National Committee on Uniform Traffic Control Devices

National Committee on Uniform Traffic Control Devices TTC TC

TOPIC: Figure 6H-28 – Typical Application 28 Sidewalk Detour or Diversion

AFFECTED PORTIONS OF MUTCD: Notes for Figure 6H-28, Figure 6H-28

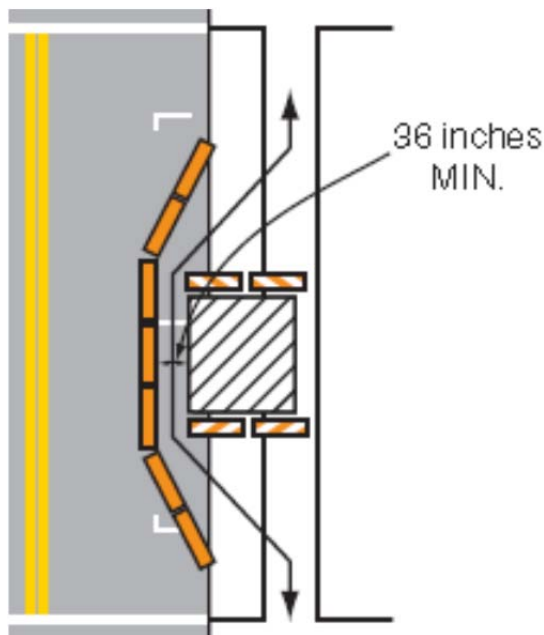
A practitioner recently contacted TTC to note a discrepancy between the Figure for Sidewalk Diversion and other sections in Part 6. Review of the practitioners comment showed several areas where this figure is not compliant with other sections of Part 6. The areas that are not compliant include:

- Lack of an accessible, detectable barricade between the pathway and the work space
- Use of a type 3 barricade to close the sidewalk which does not provide the detectability that Section 6.
- Use of the symbol for Longitudinal Channelizing Device to separate the alternate pathway from vehicular traffic without a note requiring that the LDC meet the detectability requirements of Section 6.

- Width of the alternate pathway is noted at 36 inches while Section 6. Requires 48 inch minimum
- Lack of notice to practitioners that a ramp is required when elevation changes by more than ½ inch.

Modify Figure 6H-28 Sidewalk Diversion to include longitudinal channelizing devices on both sides of the alternate pathway that are detectable to users of long canes and that have upper and lower rails as noted in 6.; adjust the width to read 48 inches minimum and depict ramps between the curb and the alternate walking surface. Modify the Notes to TA-28 to bring them into compliance with the 2009 Edition of the MUTCD and to support the modifications to the Figure. Include in the notes clarification of the use of temporary traffic barriers.

Modify the Figure in TA-28 as shown below:

Proposed Figure for TA-28
